To: ISO-NE CAR-SA Team; NEPOOL Markets Committee

From: Alex Lawton; Kris Aksomitris

Date: 09/04/2026

16-Hour Heuristic Proposal

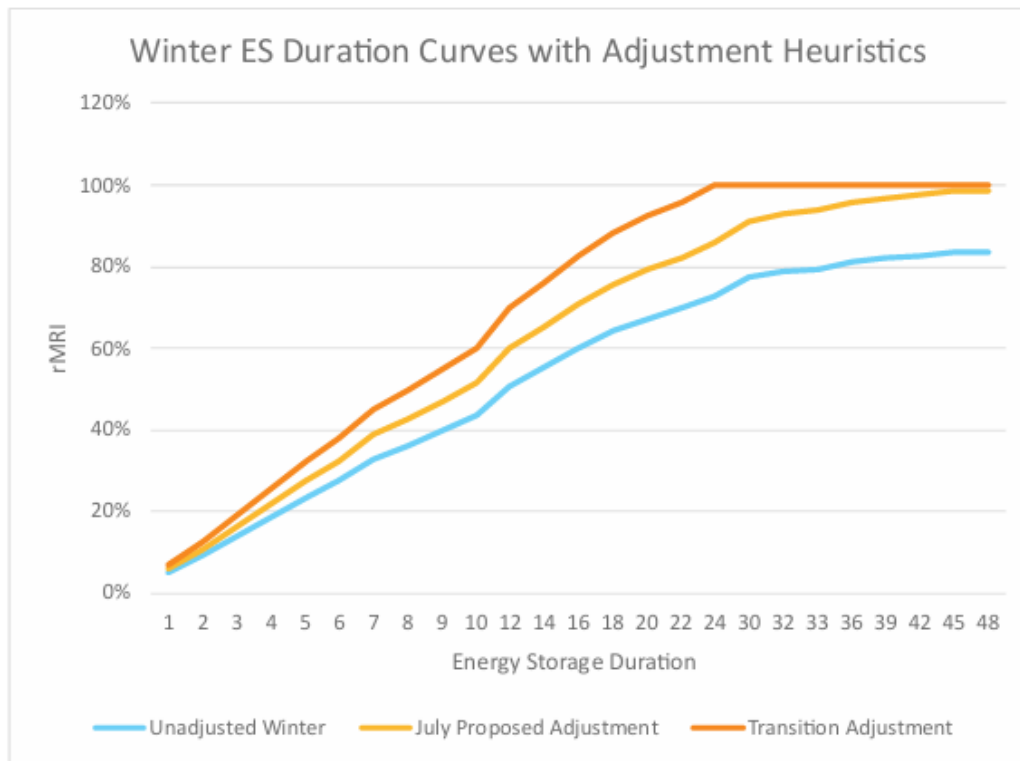
ISO-NE's proposed storage heuristic applies to the winter rMRI and adjusts rMRI such that a 24-hour energy storage unit receives an rMRI of 100% (excluding the impact of EFORD). In essence, the heuristic is that the unit's unadjusted rMRI is divided by 73% to get to the adjusted column (Transition Adjustment). For all resources with greater than 24 hours storage, the rMRI is capped at 100%.

In theory, the ISO's heuristic could be applied to a different duration such as 16 hours, which is the same duration that results in no de-rate for the energy limited thermal resource heuristic (EL3). ISO appears to be testing whether eliminating the Type 3-hour modeling constraint supports replacing the existing EL3 heuristic with a duration-based adjustment similar to the one it has proposed for storage.

We understand ISO's concern to be that if a duration such as 16 hours was used as the 'base' for storage adjustments, storage would see a higher rMRI than a similar EL3 resource in some cases. In other words, a 4-hour battery would have an rMRI of 0.31 if a 16-hour standard is used (~ equal to 19% / 60%), whereas an EL3 asset with 4 hours of energy would have an rMRI of about 0.3 (~ equal to 25% / 83.6%). This is contrary to the ISO's general result that an EL3 resource has a better rMRI than an equivalent duration ES resource because it is assumed to fully recharge daily with no reliance on surplus energy from the electricity grid.

It should not be a concern that a 4-hour ES resource has a higher accreditation than a 4-hour EL3 resource. This is realistic because the ES resource can charge or partially charge midday on some portion of events and is therefore more valuable than a 4-hour EL3 resource that is limited to a daily ‘refill’. It is largely an academic concern because ISO has indicated EL3 resources are generally longer duration than existing ES resources (our understanding is the typical EL3 resource is 12 to 16 hours).

Proposal: support using a 16-hour heuristic adjustment rather than ISO’s proposed 24-hour baseline. The rationale is that the rMRI is expected to be very similar to our previous amendment for EL3 (about 0.3 for both cases for a 4-hour BESS). The 16-hour heuristic also has the advantage of being a ‘known quantity’ given the ISO has already produced sufficient information to very confidently know the impact.
